HARTZELL PROPELLER INC.
SERVICE BULLETIN
TRANSMITTAL SHEET
HC-SB-61-363

**Propeller - Introduction of A-2051-1 Bolt with
Three-Direction Safety Wire Holes**

July 1, 2015

This page transmits a revision to Service Bulletin HC-SB-61-363.

Visual Inspection
Figure 1

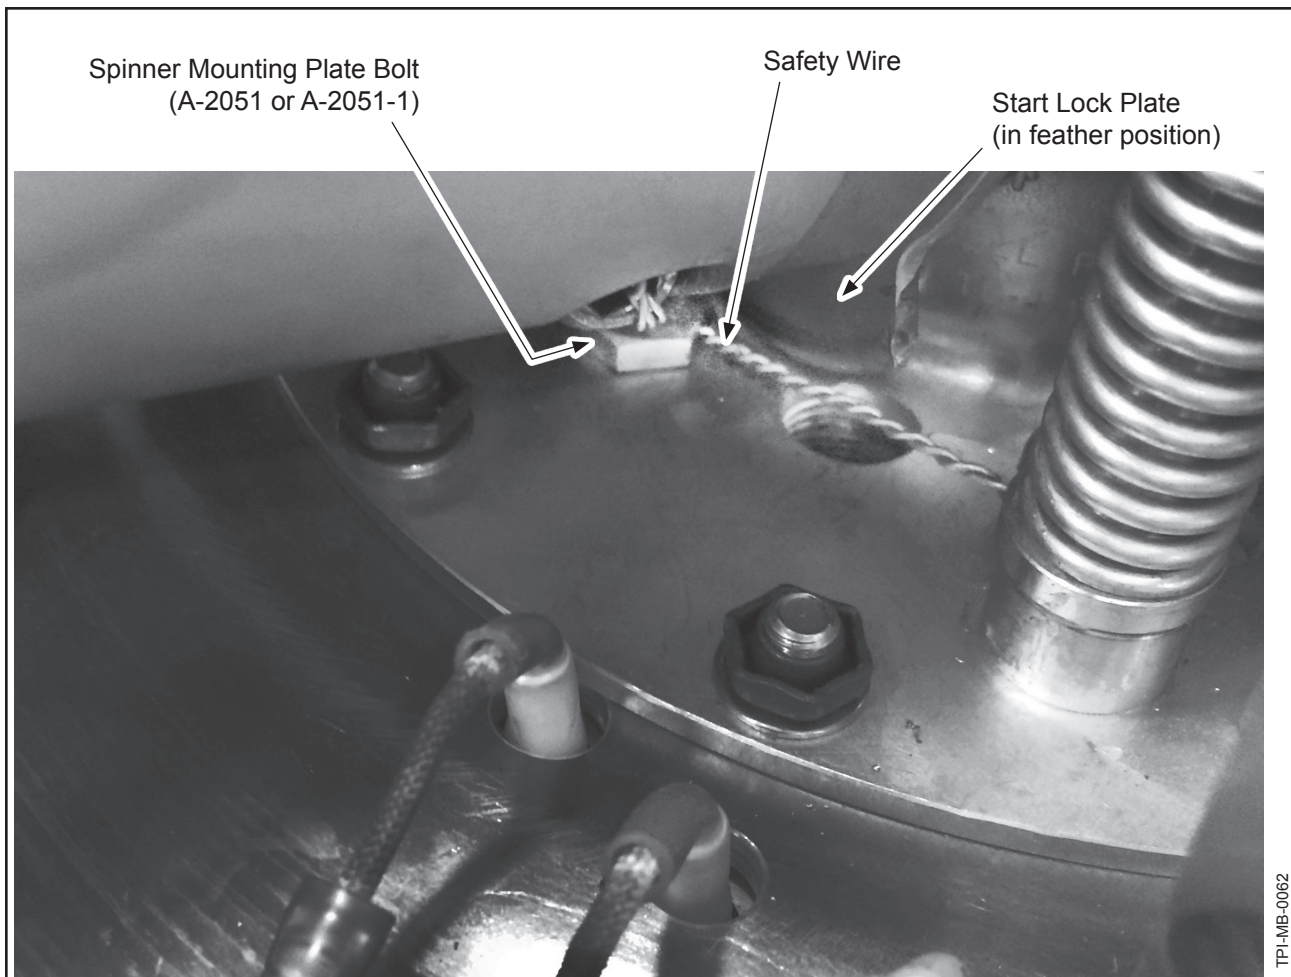
- (2) Perform the following steps at propeller overhaul or major disassembly before applying sealant to the clamps:
 - (a) Visually examine the start lock plates for interference with the safety wire securing the bolts in the spinner mounting plate. Refer to Figure 1.
 - 1 If the start lock plates touch the safety wire:
 - a Reroute the safety wire for the spinner mounting plate bolts in accordance with section 3.B. in this Service Bulletin.
 - 2 If the start lock plates do not touch the safety wire, no further action is required.

Safety Wire Routing Used by Hartzell Propeller Inc.
Figure 2

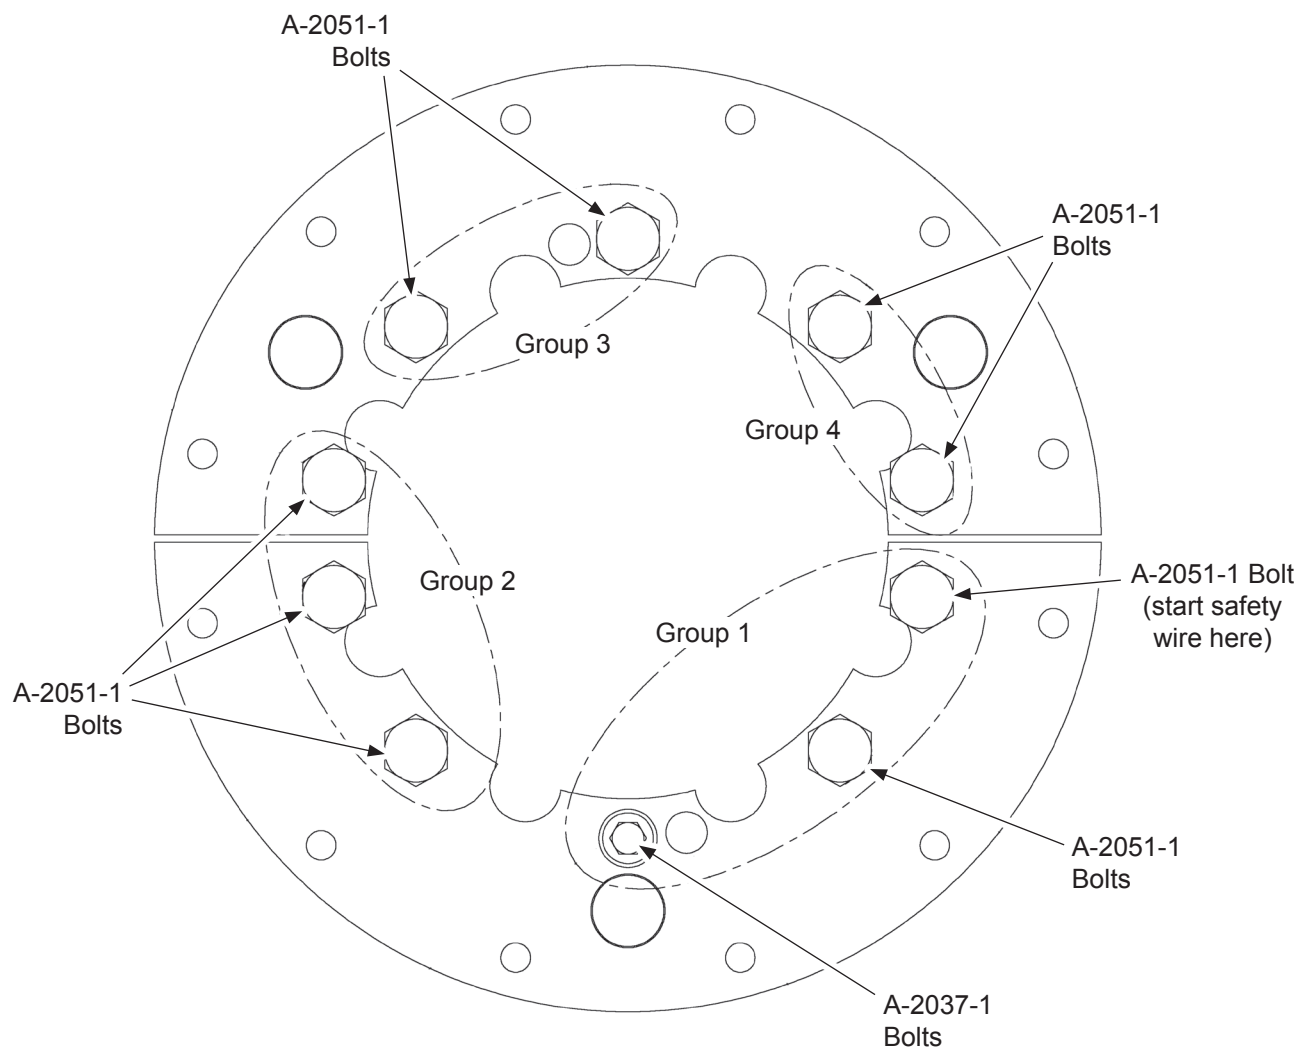
NOTE: Figure 2 shows the safety wire routing used by Hartzell Propeller Inc. when nine A-2051-1 spinner mounting plate bolts are used.

The spinner mounting plate bolts are safety wired together in four separate groups as shown.

- (1) If any of the start lock plates touch the safety wire securing the bolts in the spinner mounting plate, cut the safety wire and remove the bolt at the location of the interference.

- (2) Install a new A-2051 bolt or a new A-2051-1 bolt at the location of the interference.
- (3) Torque the new A-2051 bolt or new A-2051-1 bolt 13.5 - 16.5 Ft-Lb (18 - 22 N•m).

- (4) Examine the position of the safety wire hole(s) in the new A-2051 bolt or new A-2051-1 bolt.
 - (a) If safety wire can be installed without interfering with the start lock plate:

- 1 Safety wire the bolts together with 0.032 inch (0.82 mm) diameter stainless steel wire CM131 in accordance with NASM33540.
 - 2 Complete the propeller overhaul in accordance with Hartzell Propeller Inc. Steel Hub Turbine Propeller Maintenance Manual 118F (61-10-18).

- (b) If the safety wire interferes with the start lock plate, repeat steps 3.B.(1) thru 3.B.(4) as necessary.
